CIVIL ENGINEERING REPORT

Proposed Development on Portion 91 of Farm 304 Matjes Fontein NOVEMBER 2024

Dr NICKY FROOTKO
PLETTENBERG BAY
6600

ZS2 CONSULT (Pty) Ltd

Figure 2D: SEWAGE DEMAND: LEVEL CLEARED AREA OF PROPOSED DEVELOPMENT

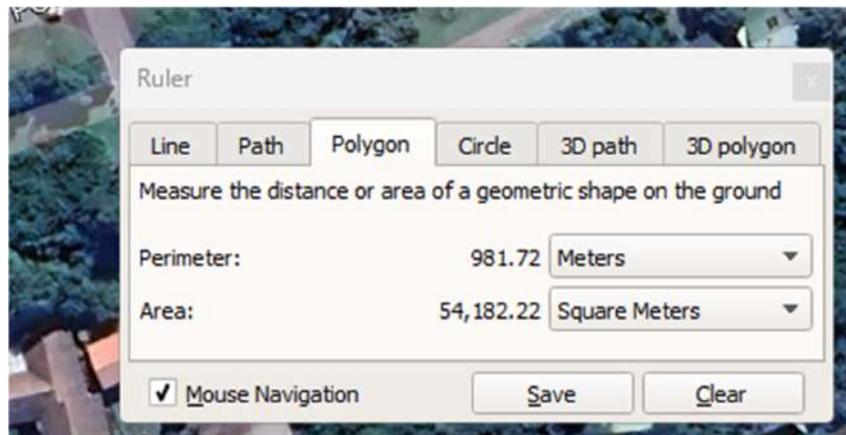
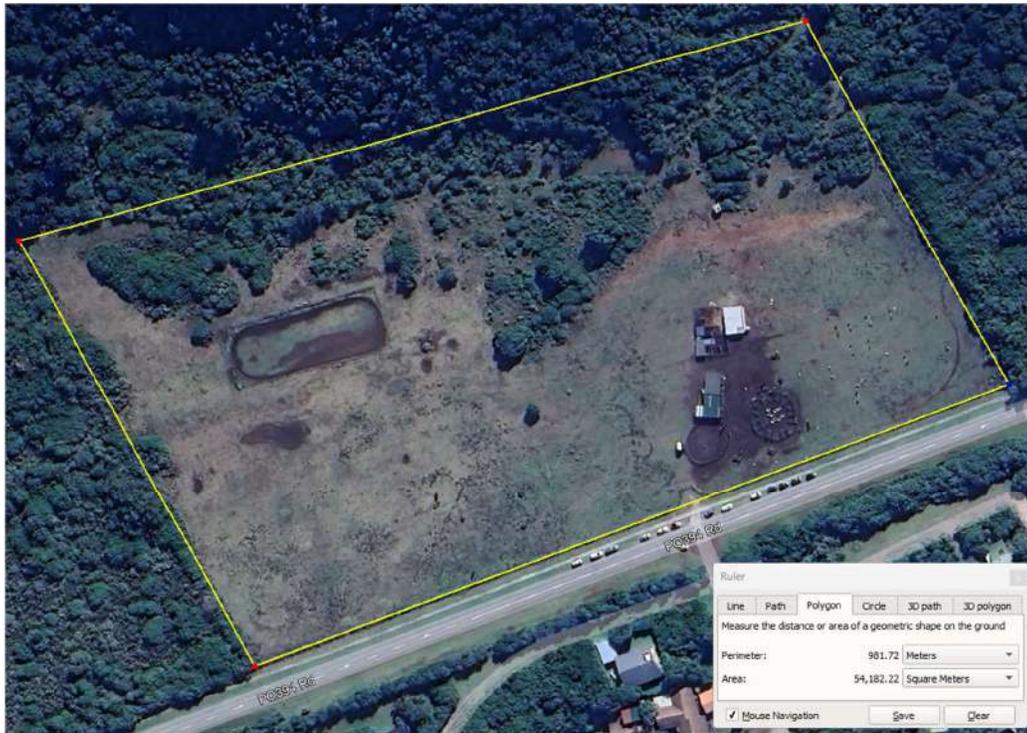
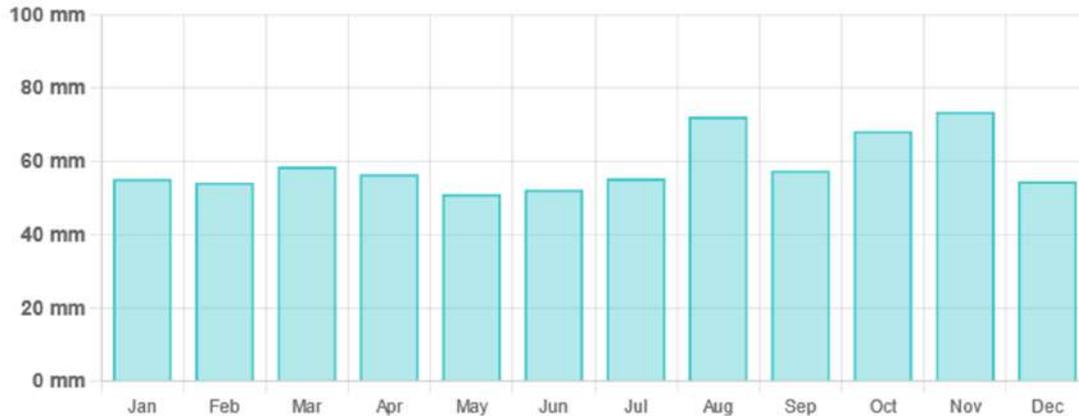
The developer proposes to dispose of the treated wastewater on site by means of irrigation and other. The volume of treated wastewater from rough estimated calculations will be in the order of 36000 litres per day. Now to put this volume of water in perspective the following: The area of development is approximately 54182 m² (level cleared area of site as per Figure 2D). Now the irrigation area is assumed to be 30% x 54182 m² (70% are buildings and roads and retention ponds and other) equals to 16255 m² (irrigation area).

Now 36000 litres per day divided per 16255 m² equates to 2.215 litres per m² or 0.002215 m³ per m². This the equivalent of 2.215 mm of rain per day or 808 mm per year.

The treated water generated by the sewer treatment plant is more than double the average 710 mm rainfall for the Keurbooms Strand area, if it is compared to the estimated available irrigation area on the development area.

We are therefore concern that the volume of generated treated water is too excessive to be utilised on the site as per the intention of the developer.

Figure 3B: STORMWATER: SECTION A-A

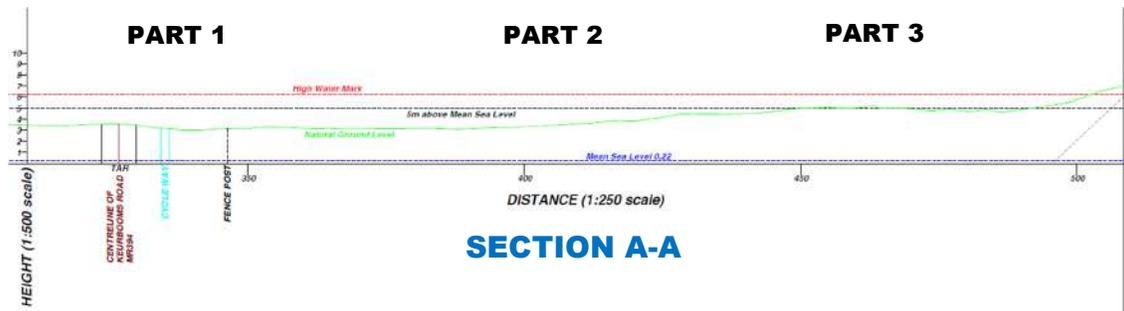
The stormwater management is problematic on the proposed site. The site has two high points, one very high on the northern boundary (labelled as “HP2”) and another low high point at the southern boundary against the Keurbooms road (labelled as “HP1”). This means that storm water that is generated on the site and on the northern adjacent high lying area is land locked on the site with no natural drainage of the site possible.

The land locked site with the trapped stormwater between the high points is illustrated below with the enlarged Section A-A part 1, part 2 and part 3.

Figure 3F: STORMWATER: PART 1 OF SECTION A-A ENLARGED

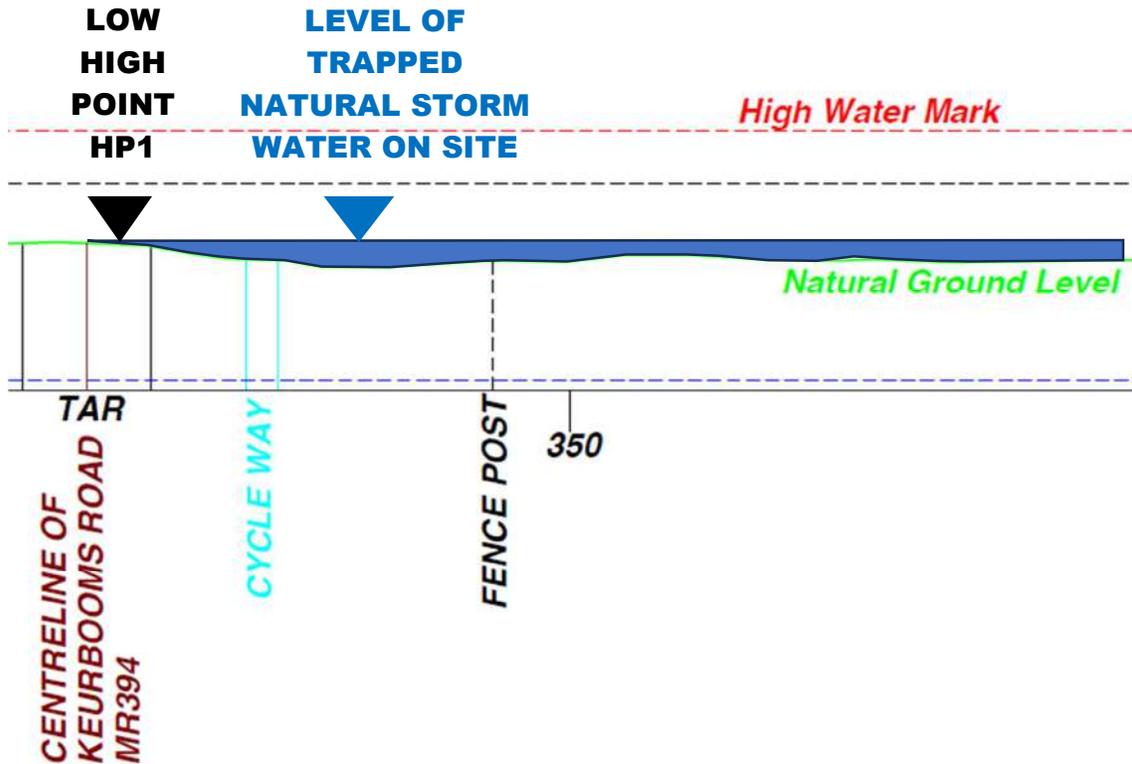
The land locked site with the trapped stormwater between the high points is illustrated below with the enlarged Section A-A part 1, part 2 and part 3.

However, in this case the existing water table is very high due to the low ground levels and nearby estuary. Refer to next paragraph 5.3. We have not seen to date any drawings indicating the proposed location of these ponds on the site, but these ponds will obviously be located at the low points on the site so that stormwater will gravity feed to these ponds.

Unfortunately, the lower the invert level of the ponds, the closer the bottom of the pond will be to the existing high water table level, and it might even be below the existing water table level. This high water table is very problematic for the draining process of the proposed retention pond as the high water table will prevent these ponds from draining and thus defy the objective of the design principal of these ponds. These retention ponds will thus be ineffective.

In our view, because of the reason provided above, the proposed stormwater design of the proposed development is flawed.
